APPLICATION NO.	FILING DATE	FIRST NAMED INVENTOR	ATTORNEY DOCKET NO.	CONFIRMATION NO.
10/823,740	04/14/2004	James J. Robinson	033679-532	4901

Office Action Summary

DETAILED ACTION

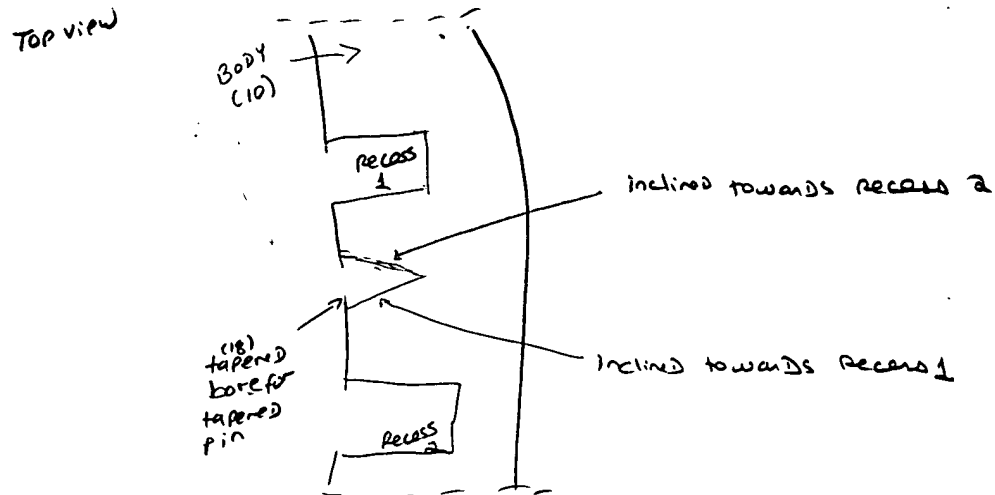
Kelly et al. teaches in Figure 5, a tool body (23) for a rotatable cutting tool having at least one recess (24) with a first and second opposing walls for releasably retaining a replaceable insert (25 with exposed cutting edge), an isolating channel/slot (17) spaced from the recess to define an elastically deformable leaf there between, wherein the first wall of the recess is formed by the leaf. Kelly et al. also teaches a tapered pin (leaf bending element) (19) adjustable within the isolating channel for elastically bending the leaf from a relaxed position to a clamping position wherein the first wall clamps the insert against the second wall. Furthermore, Kelly et al. teaches in Figure 5, first wall that is inclined at a shallow angle relative to the second wall and when the leaf is in the relaxed position, the first wall diverges from the second wall in a direction away from an open end of the recess (('951, Col. 3, lines 45-56). Kelly et al also teaches tapered bore (18) which is part of the isolation channel (17) therefore each side of the taper is inclined at a shallow angle towards a recess of the opposite side, in a direction away from an open end (in a direction looking into the page of figure 1) of the isolation channel (see below).
